1CAN071501

SUBJECT: 90-Day Response to Request for Additional Information
Adoption of National Fire Protection Association Standard NFPA-805
Arkansas Nuclear One, Unit 1
Docket No. 50-313
License No. DPR-51

**90-day Responses to Request for Additional Information
ANO-1 Transition to NFPA-805**

Figure 1 – Input parameter variance on the CDF evaluation

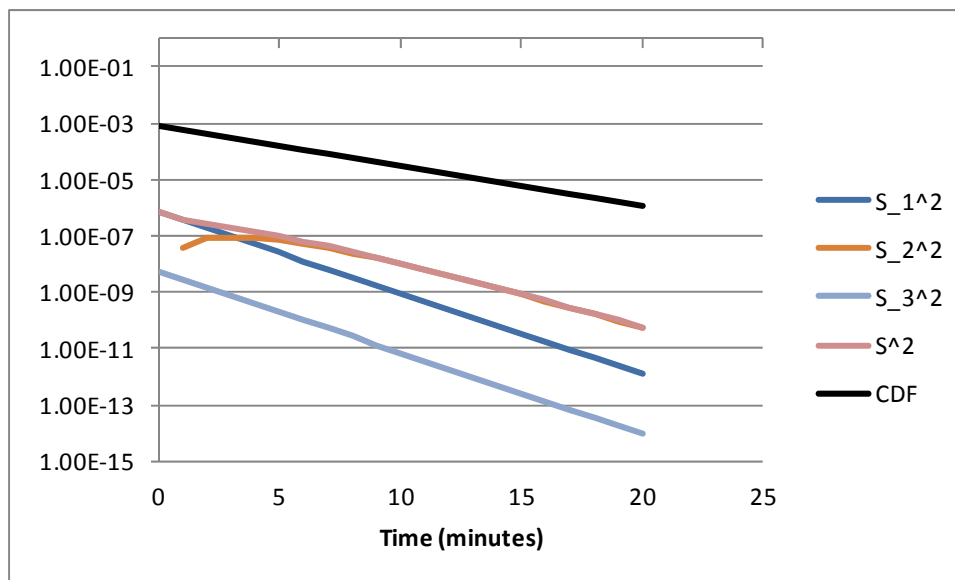
- (i) A baseline fire scenario is considered insensitive if the change in the total probability of control room abandonment remains less than 15 percent. Please provide technical justification for the 15 percent criterion.
- (ii) The sensitivity analysis appears to indicate that raising the fire base to 1.2 m or 2.4 m significantly reduces the abandonment times for scenarios without operating HVAC. Please explain why the baseline scenarios were not updated to include the higher fire elevations.

- p)(i) The selection of fifteen percent criterion for model sensitivity to input parameter uncertainty is justified based on several considerations of the MCR abandonment application. The first consideration is that the process used to incorporate the parameter sensitivity into the baseline assumptions is conservative. This can be demonstrated by describing the process in more detail. The second consideration is that the fire modeling results of MCR abandonment are simply used as an input in a larger PRA model that includes various parameters with accepted levels of uncertainty. Given that the PRA model contains a significant amount of uncertainty, it can be shown that the additional uncertainty contributed by the assumed 15 percent threshold is insignificant. These factors taken together justify the selection of 15 percent model sensitivity to input parameter uncertainty.

Figure 1 shows that the total variance attributable to the uncertainty in the time to abandonment is approximately two to four orders of magnitude smaller than the total variance. This means that the contribution to uncertainty of CDF is completely dominated by the uncertainty in λ_g and λ and that the assumed uncertainty of fifteen percent in the parameter t is negligible by comparison. For example, the assumed uncertainty in the parameter t could be ten times greater than what is currently assumed without having an adverse impact on the total uncertainty in the PRA.
